Citation for Non-Compliance
Utah Coal Regulatory Program
 1594 West North Temple, Salt Lake City, UT 84114
 Phone: (801) 538-5340 Fax: (801) 359-3940

Citation #: 16150
Permit Number: C0250005
Date Issued: 04/08/2015

NOTICE OF VIOLATION **CESSATION ORDER (CO)** **FAILURE TO ABATE CO**

Condition of Ditch 1, Ditch 4 and Best Technology Currently Available:

Figure 4: March 24th inspection. The red arrow points to the location where Ditch 1 failed allowing disturbed area runoff carry suspended sediment offsite untreated.

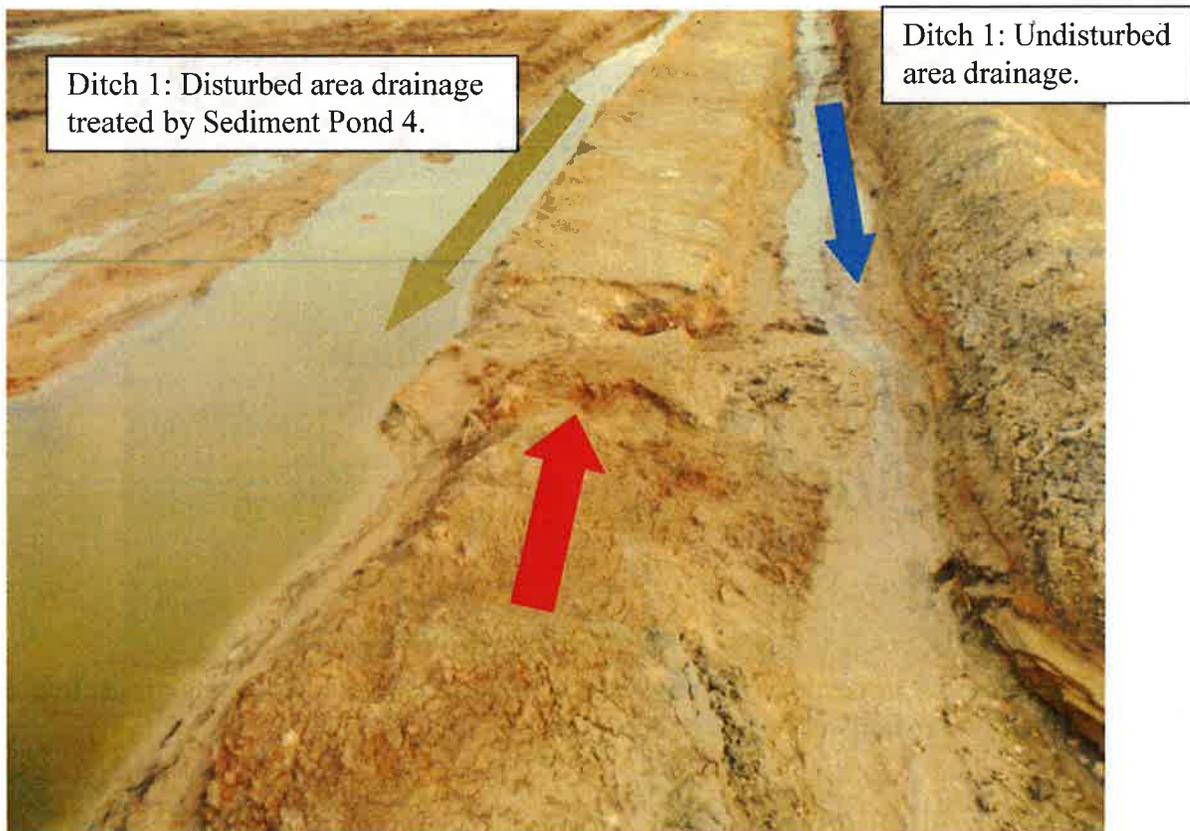
Alton Coal Development, LLC (ACD) failed to properly construct and maintain Ditch 1 and Ditch 4. Surface runoff from snow melt breached both ditches in early March, allowing suspended solids to leave the Permit area untreated. Additionally, the Permittee failed to properly maintain best technology currently available at the outlet of Ditch 1 and at the end of Lower Robinson Creek reconstruction. During the runoff event these sediment controls did not properly treat surface runoff and prevent additional contributions of suspended solids to streamflow outside the permit area.

- 2) Ditch 1 must be built to the approved design shown in Drawing 5-33. This design shows Ditch 1 capturing runoff from the undisturbed area to the east and having a 1' berm running along the western edge of the ditch.

- 4) The west side of Ditch 1 (disturbed runoff side) will be graded and sloped to drain water to Sediment Pond 4's inlet. No ditch or depression may run along the western side of the Ditch 1 berm.

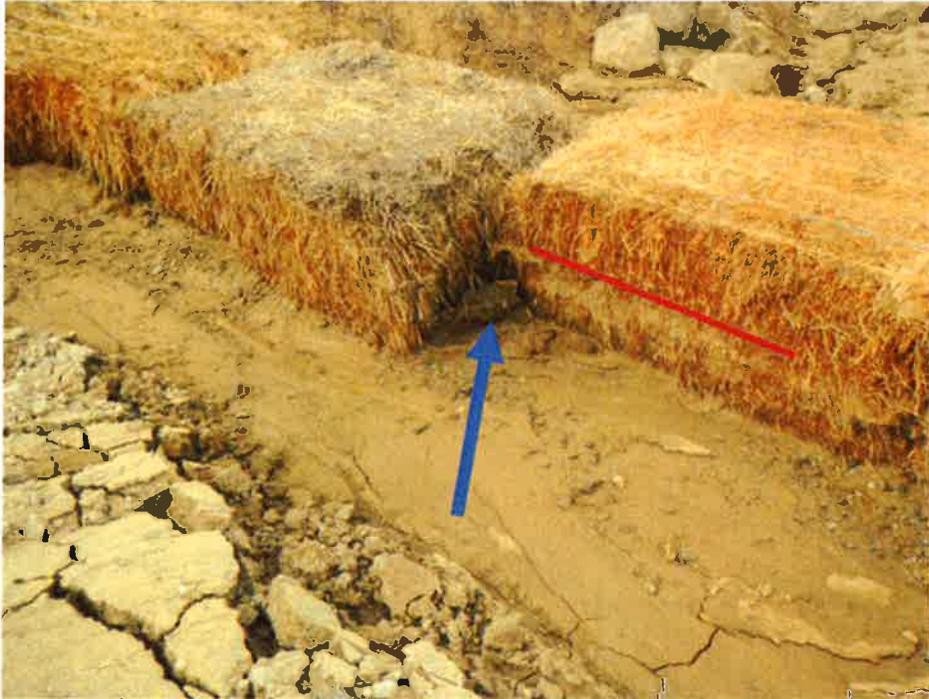
Figure 23: March 24th inspection. The straw bale check dam did not properly treat disturbed area runoff. Instead of ponding runoff and allowing to suspended sediment to settle out, the runoff piped under and between the two abutting straw bales. The red line indicates the height water pooled, before flowing under and through the joint.

The straw bale check dam at the outlet of the reconstructed Lower Robinson Creek needs additional maintenance. A properly functioning straw bale check dam in this location will capture runoff and allow it to pond and settle out suspended solids prior to allowing runoff to flow offsite.
